## **B-R) Remarks to the specifications amendments**

**November 22, 2003 10/038,459**

**C-R) Remarks on the Amendments to the drawings and figures**

**Annotated Marked-up Drawings: 11-22-2003 10/038,459**

**Fig. 1(b)**

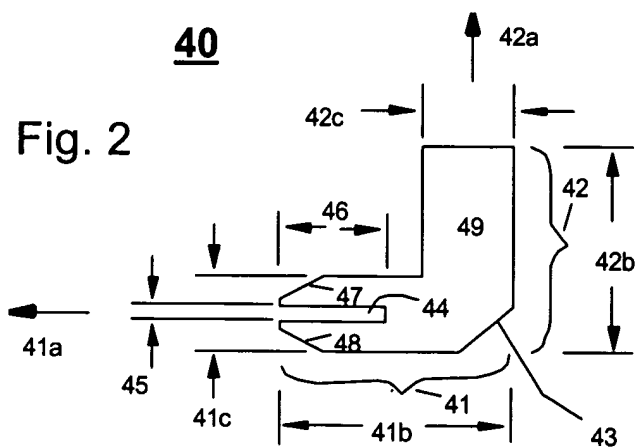
Fig. 1(b): numeral “39” has been added to indicate the E-field. Wavy arrow has been added to replace the original arrow to represent microwave signals. [Remark 1]

**Fig. 1(c)**

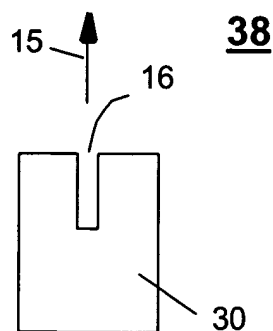
**“Fig. 1(c) shows a prior art waveguide probe (38) with a main probe body (30) and a slot (16). The slot has an axis (15) for connection to the first part (7) of central metal pin (2). According to the prior art structure, the electric field or E-field (39’) of the microwave signals (39) will be perpendicular to the broad side walls (32,33) or parallel to broad walls (20b) defining a reference plane as depicted in Fig. 3(a).” has been added after “ --- signals (39) to be propagated.” To describe the features of the waveguide probe. [examiners’ Remark No. 4 ]**

**Fig. 3(a)**

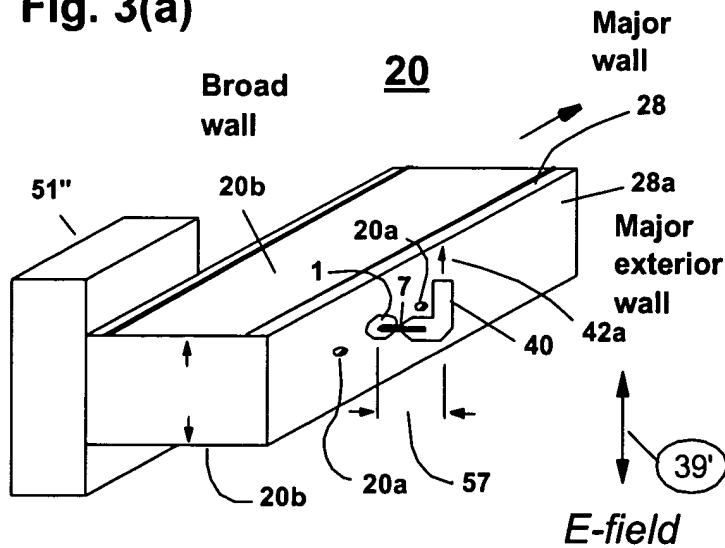
**“as shown in Fig. 3(a)” has been added after “conductive housing” {Remark 2]**

Fig. 3(a): numeral “39” has been added to indicate the E-field. The horizontal arrow has been deleted to clarify the E-field. [Remark 1]

**Fig. 3(b)**

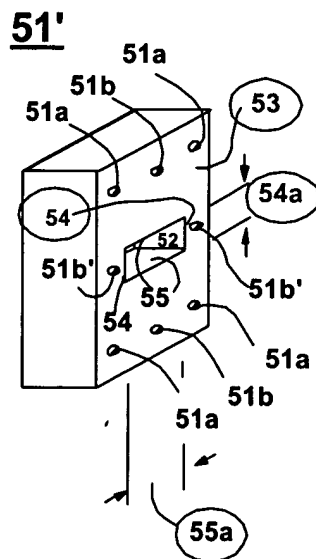
Fig. 3(b): numerals “52”, “53”, “54”, “54a”, “55a” and arrows have been added to clarify key features. [Remark 5]

**Fig. 3(d)**

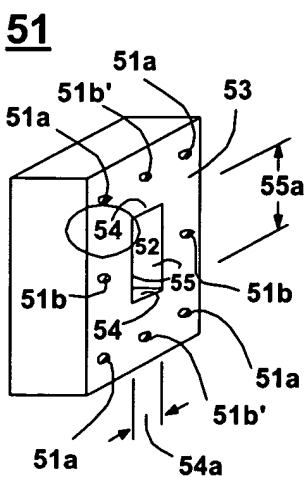
**“(51) as shown in Fig. 3(d)” has been inserted between “The universal launcher adapter” and “is constructed by metals --. , alloys or plastic materials with layers of metals coated on all walls. A through channel (52) is arranged “region” has been inserted between “-- in the center” and “of the broad wall (53).” [Remark 3]**

Fig. 3(d): numeral “54” and a guide line have been added [Remark 5]

**Fig. 3(c)**

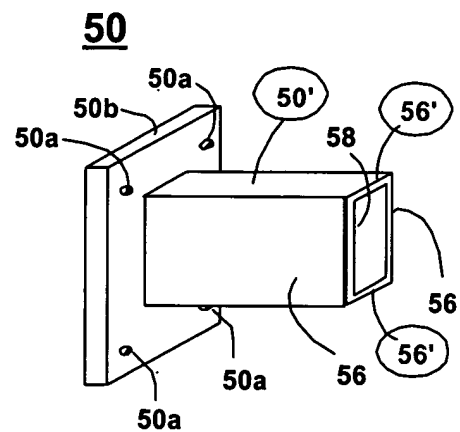
Fig. 3(c): numeral “50’ ”, and 56’ “ have been added. [Remark 5]

Fig. 4(c)

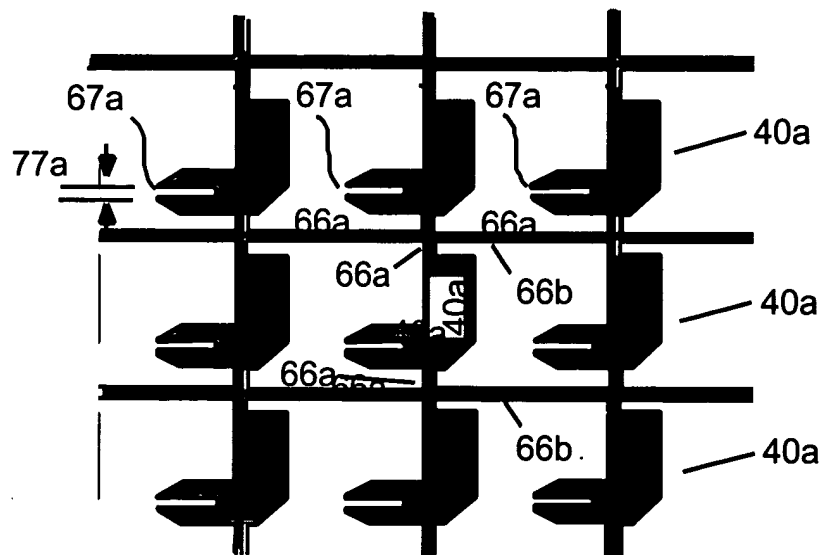
Fig. 4©: numerals “69” have been replaced by “40a” [Remark 4]

New sentences **“Each of the L-shape waveguide probes (40) formed is covered by a photoresist pattern (40a). It is noted that due to the etching, there is an edge recess or undercutting (U) in the peripheral regions for each waveguide probes (40).” have been added to replace “**~~Here, L-shape waveguide probes (40) are created by the etching.~~**”** to describe undercutting and features shown in Fig. 4. [Remark 4]
